TSB0204: 2004 King 50 & CM 50 clutch springs (Belleville washer)

April 1, 2004

Figure 1 - Four stack

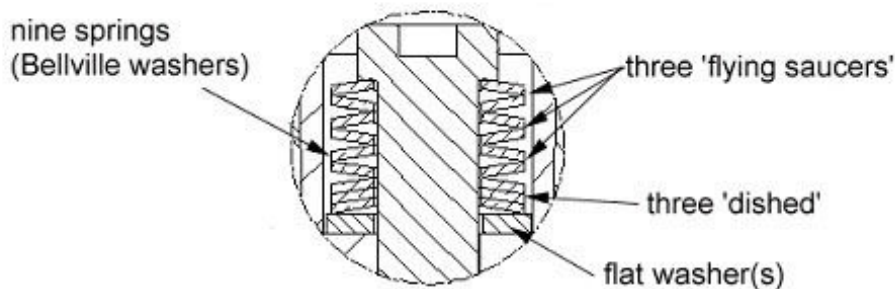
Be sure that the assembled spring stack measures 0.484 ± 0.005 (12.3 ± 0.13 mm). To achieve this you may need to rearrange the spring stack into either the three or four 'flying saucer' stack configuration.

Optional 'three' stack for smoother,
less aggressive power delivery
